REGULAR MEETING OF THE PLANNING BOARD
WEDNESDAY, JULY 24, 2019
7:30 PM
151 MARTIN STREET, CITY COMMISSION ROOM, BIRMINGHAM, MI

SUBJECT: 588 N. Old Woodward – Sweetwaters Coffee & Tea – Final Site Plan & Design Review & Special Land Use Permit

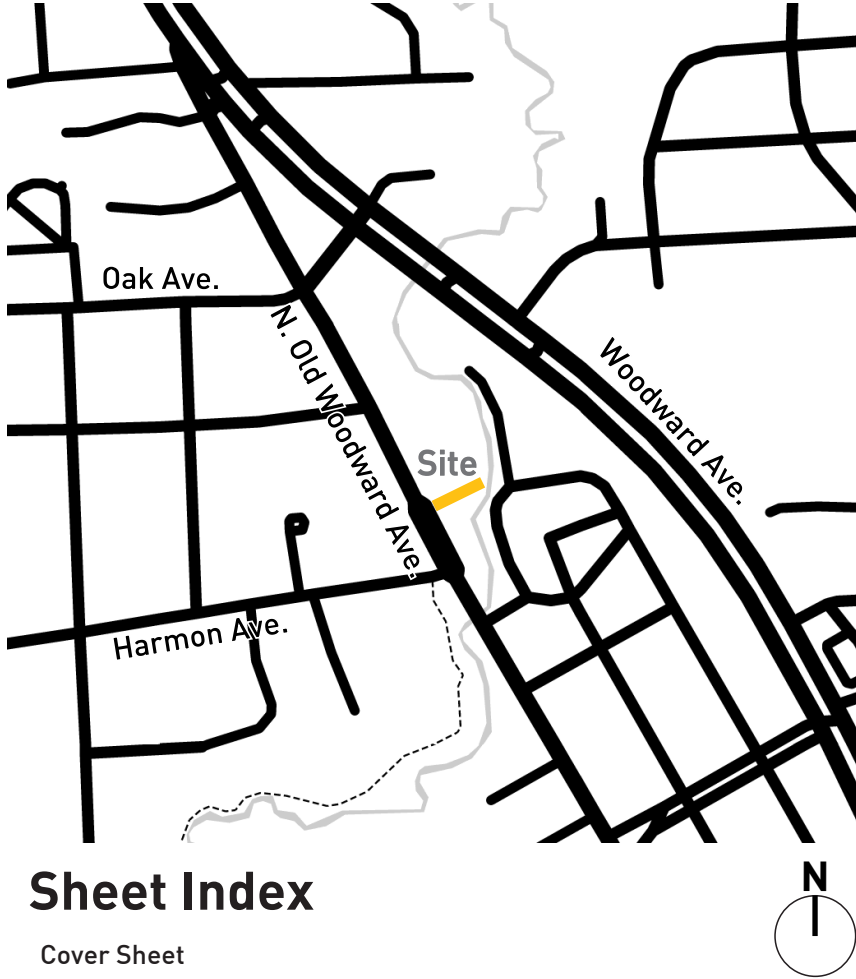
<u>Rooftop Mechanical:</u>	Required:	Screened from view
	Proposed:	Applicant must submit specification sheets for all rooftop mechanical to determine if units will be fully screened by the 5' tall metal panels proposed.

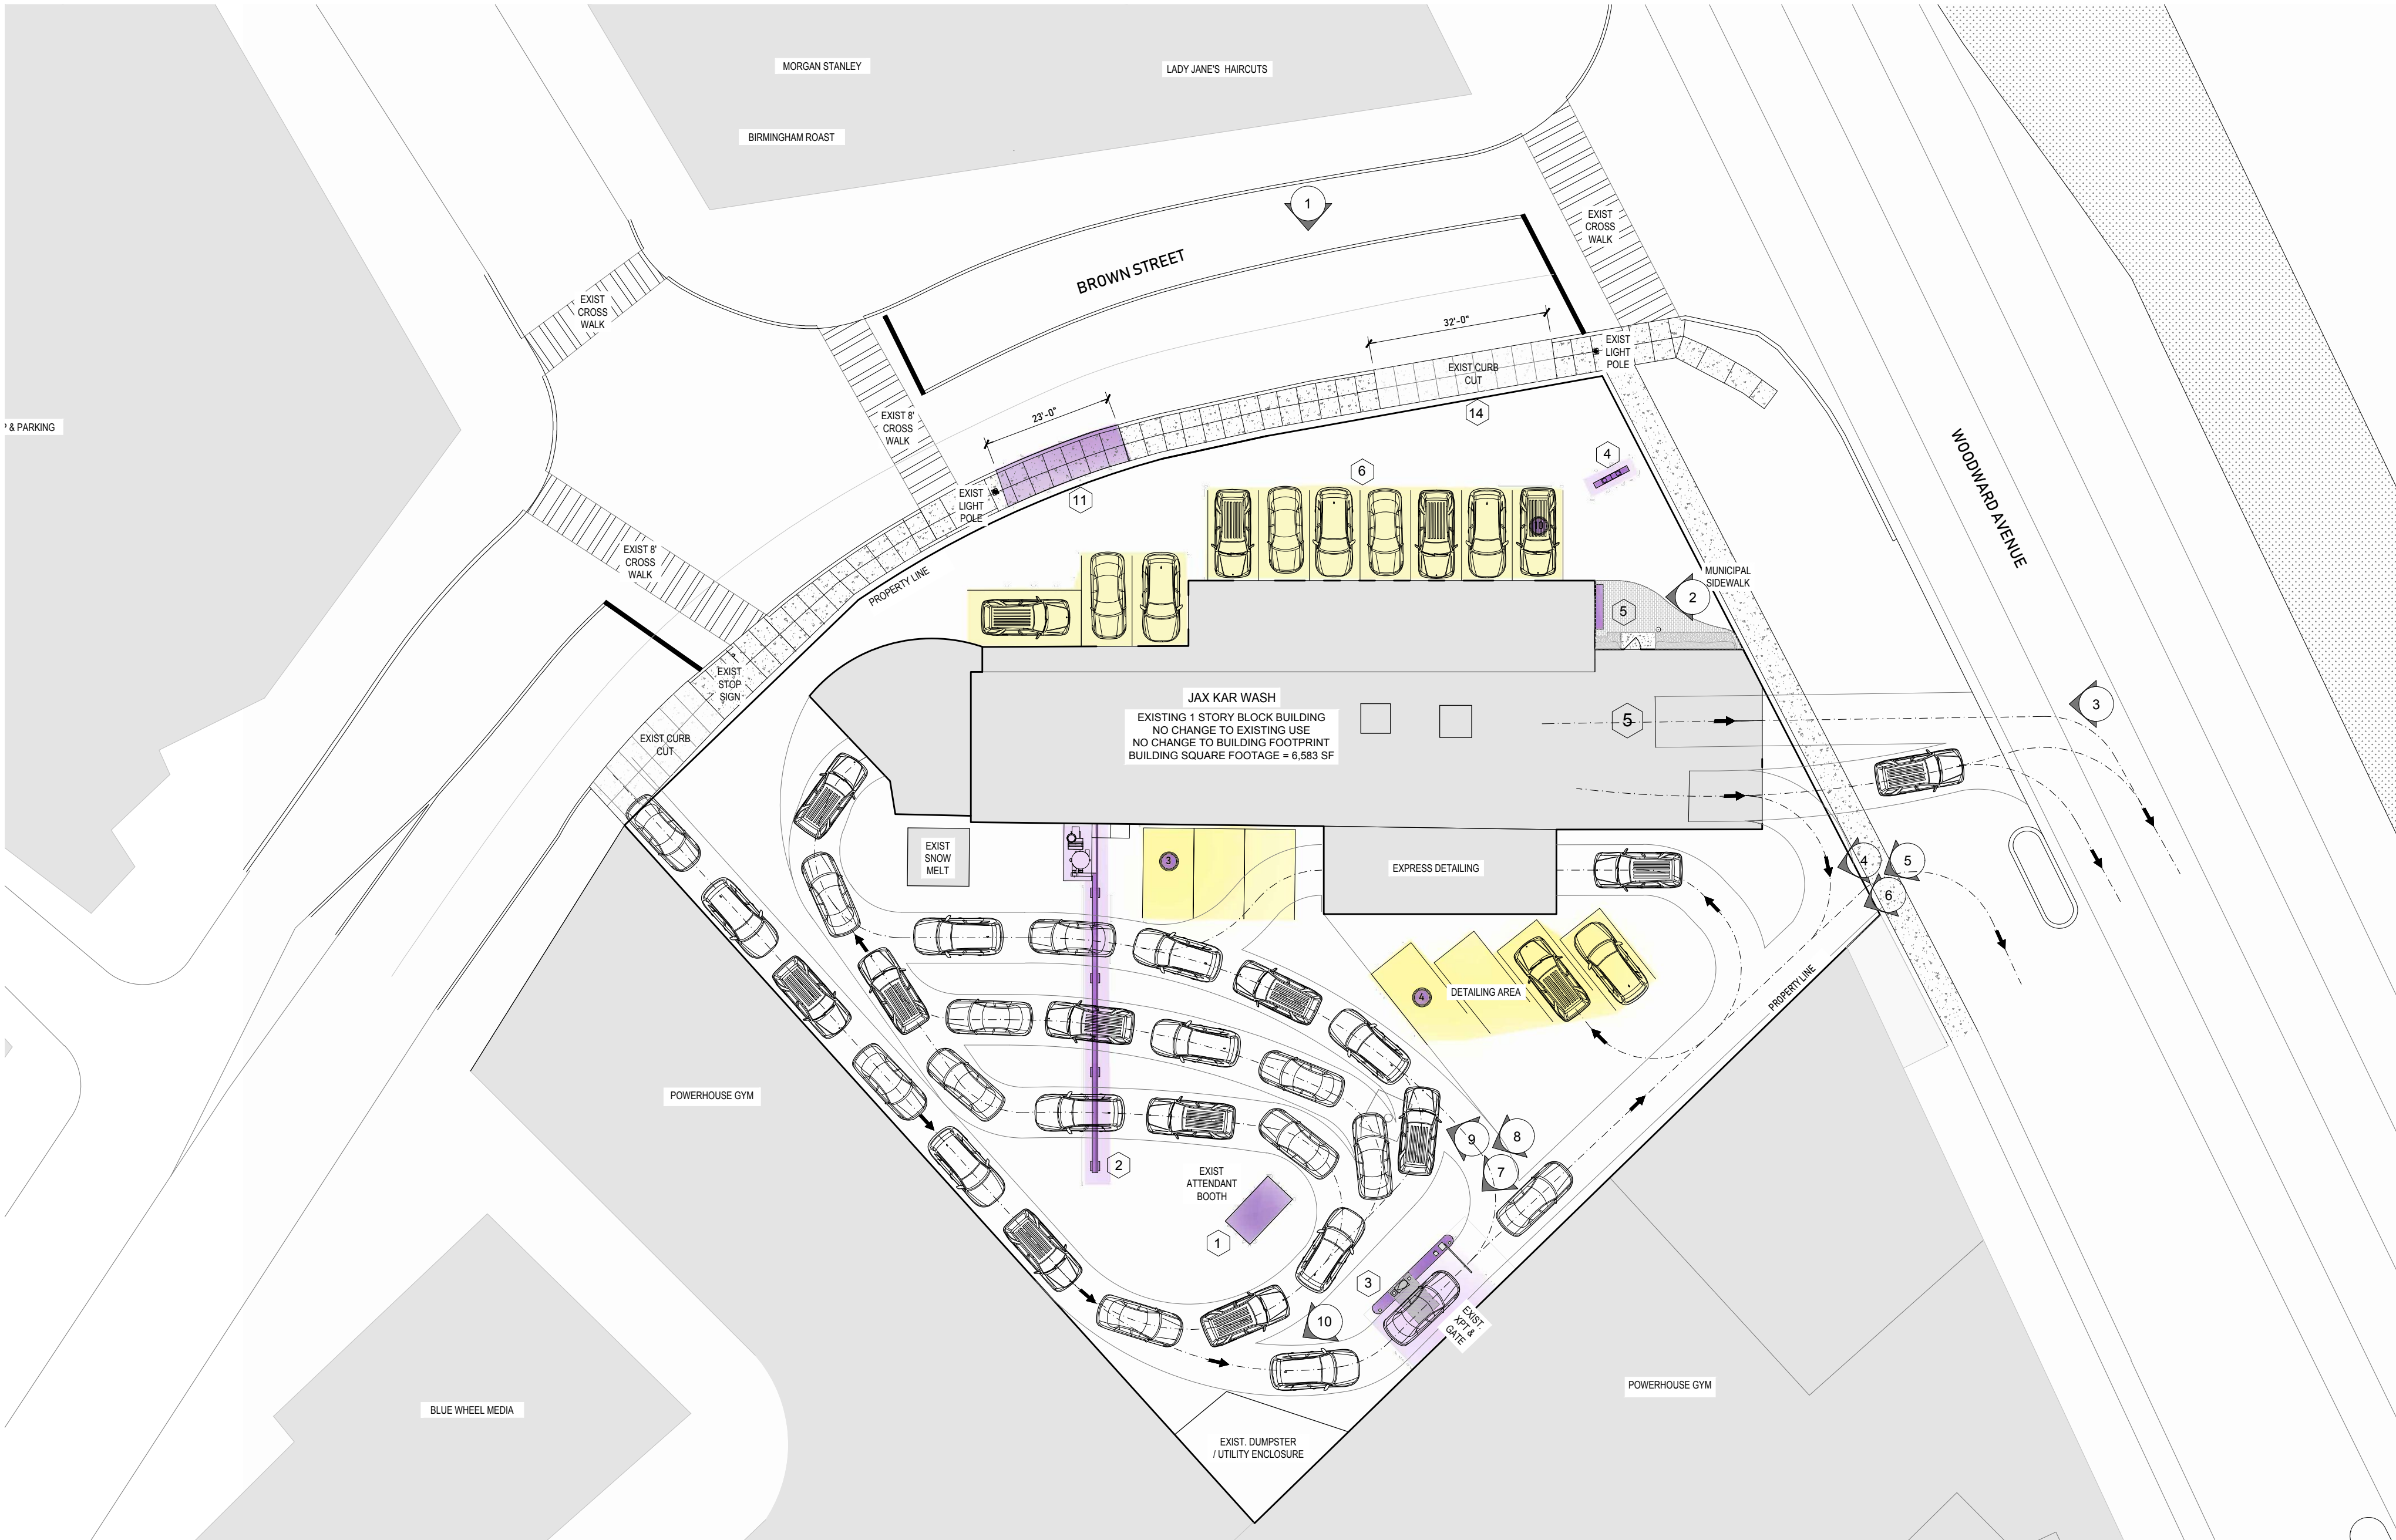
Parking: Required: Required along the front & side
Proposed: No screening proposed (**The applicant must submit plans showing parking lot screening along the front and side of the parking facility, or obtain a variance from the Board of Zoning Appeals**)
